Washington Metropolitan Area Transit Authority

Board Action/Information Summary

Deanwood DCPL Joint Development Agreement

SUBJECT: APPROVAL OF PUBLIC HEARING STAFF REPORT AND AMENDMENT OF
MASS TRANSIT PLAN FOR CHANGES AT BROOKLAND-CUA METRO
STATION

Legend

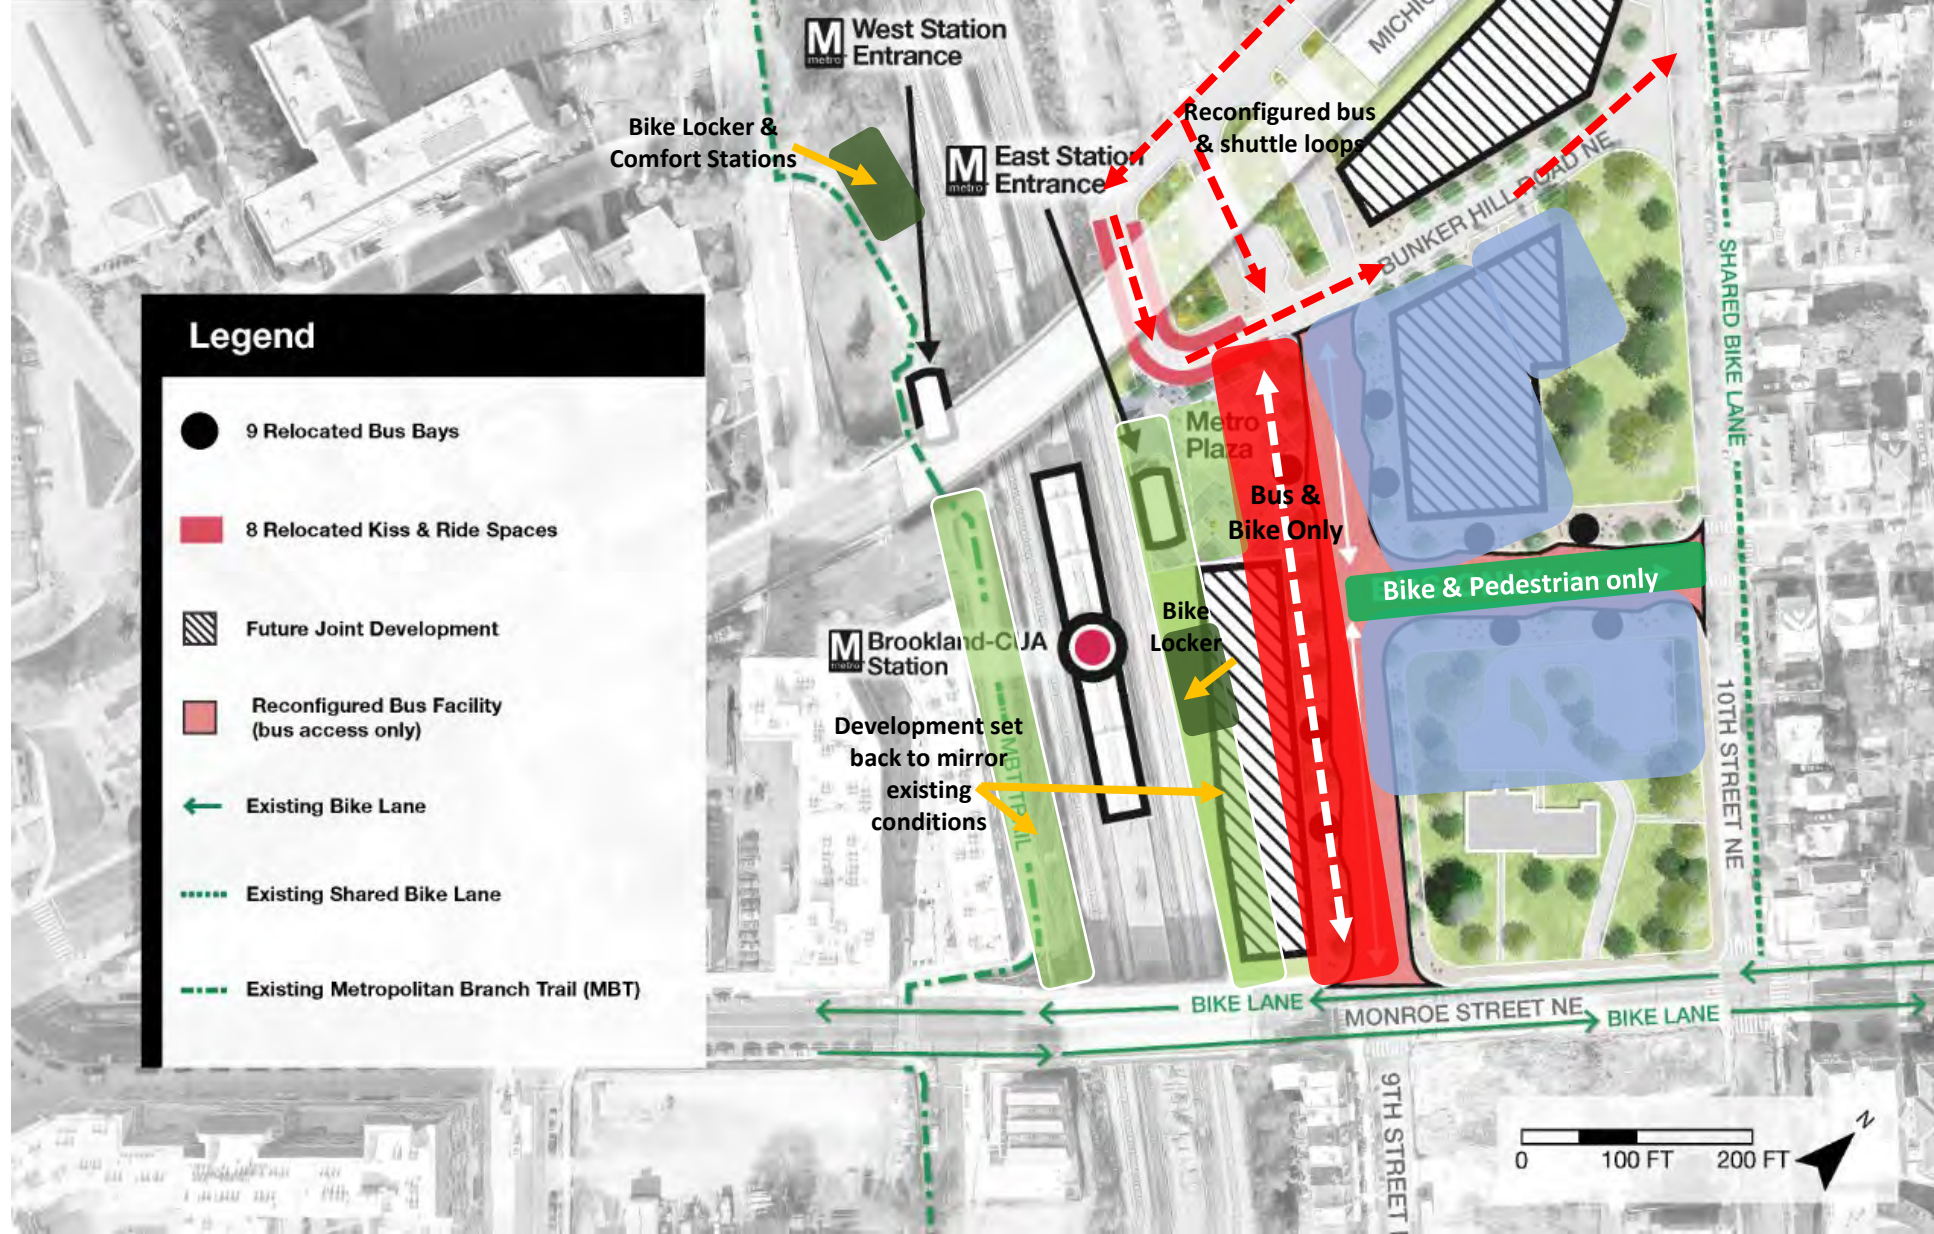
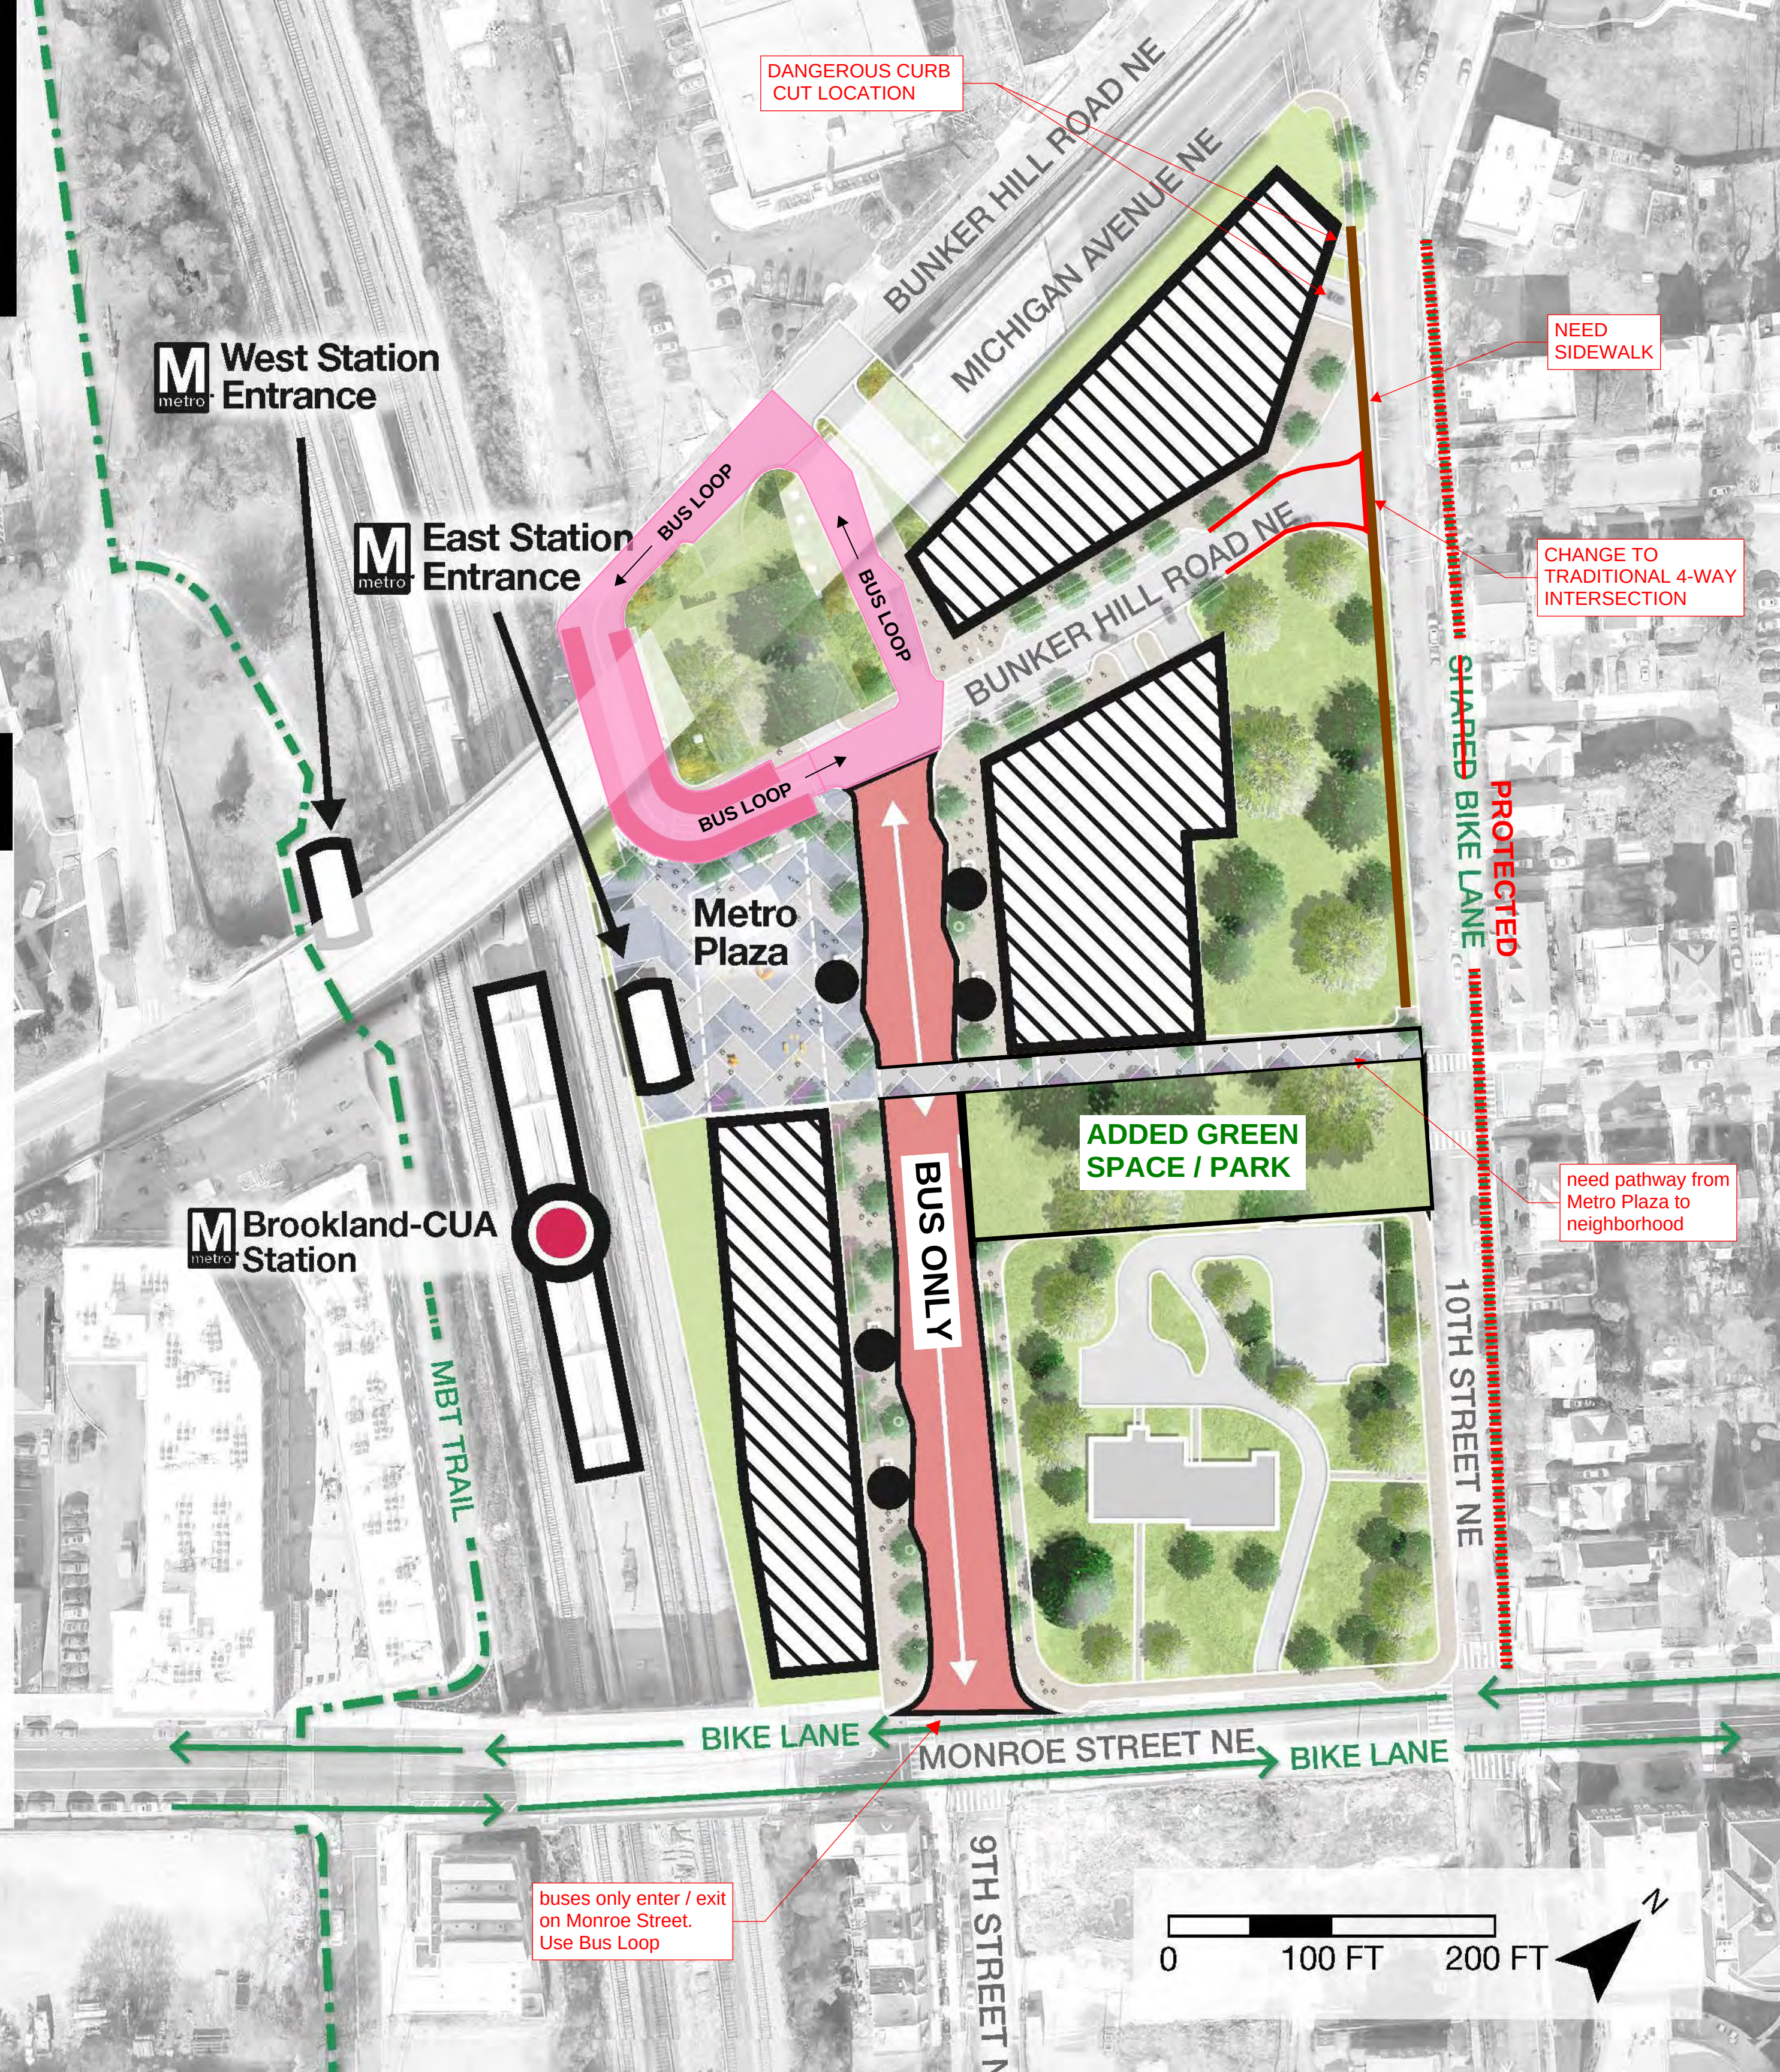
1) The most eastern development pad in the proposed configuration will likely be 1) too costly to construct being so close to the train tracks and with significant grade differences, and 2) likely cannot be easily loaded or parked with the proposed dimensions. It is recommended WMATA mirror the existing setback and trail that the Monroe Street Market development currently shows across the tracks.

2) Bus traffic should be analyzed to be routed around and onto Bunker Hill Road below the Michigan Avenue bridge and onto a new 9th Street Bus and Bike Only road. The existing shuttle buses ride south from Bunker Hill Road onto 10th Street NE (from Otis to Monroe Sts NE) and the shuttles cannot safely make the turn with 2 lanes of car traffic, one lane of parked cars, and cars at the intersection on Monroe with the existing bike lanes. The shuttles regularly drive over the curb and through the bike lanes to create dangerous pedestrian and bike conditions.

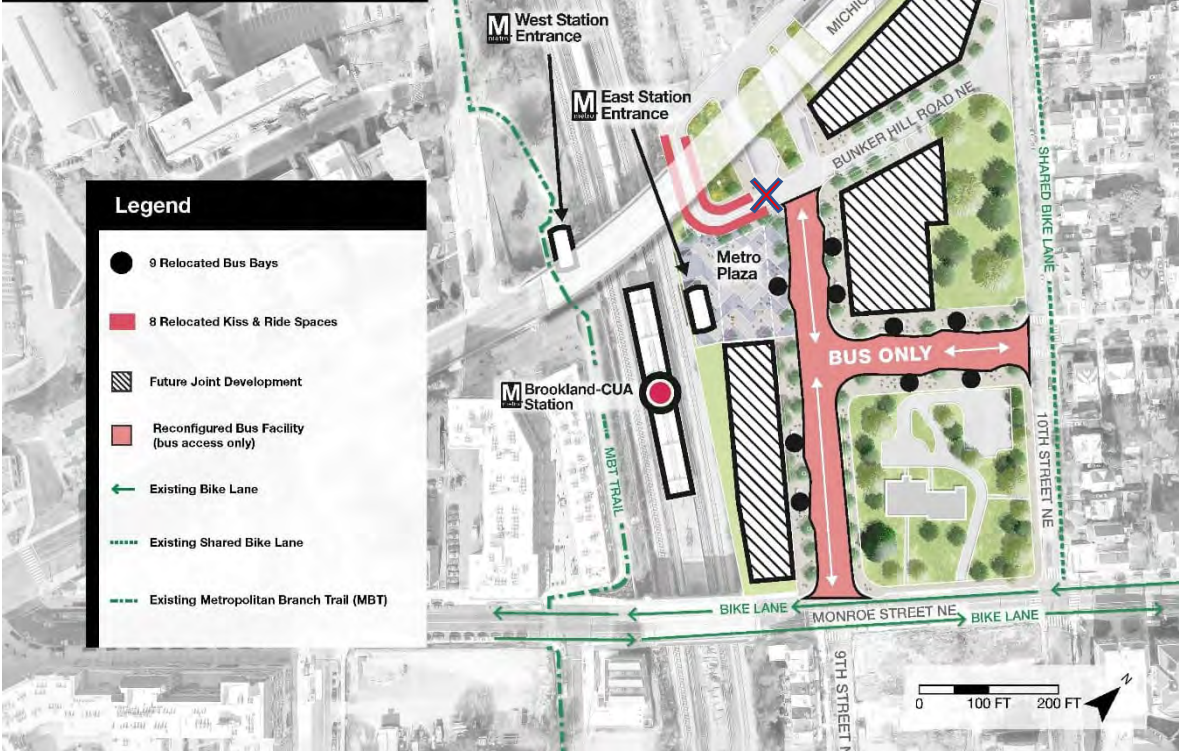
Again, due to concern for safety and cost concerns, I would like to make THREE proposals to the current Metro's Proposed Changes:

1. Consider making the hospital shuttle bus pick up segment on Bunker Hill Road (the double red lines on the map) a ONE-WAY segment.
This short segment carries a huge amount of bi-directional traffic. There are shuttle buses, commuter vehicles going into the Childrens' Hospital Parking lot, and Kiss-N-Ride cars. During rush hours, with shuttle buses taking up one lane to load and unload riders, the remaining lane quickly becomes congested and blocked by cars going both directions around the shuttle buses. By designating the short segment ONE WAY (counter-clockwise on the map) and placing a ONE WAY - DO NOT ENTER sign on the south-east end (red X), the traffic will improve significantly with added safety. Vehicle coming out the ONE-WAY segment can go straight from the right lane or turn left from the left lane to head north.

2. Round off the sharp acute right turn from Michigan Ave to 10th street (blue X).
This acute right turn is very difficult for large vehicles to maneuver around. Buses must struggle and take extra time and caution making the turn. This often stops traffic on Michigan Ave going east, and cars on 10th street going north having to yield their lane to the turning bus.
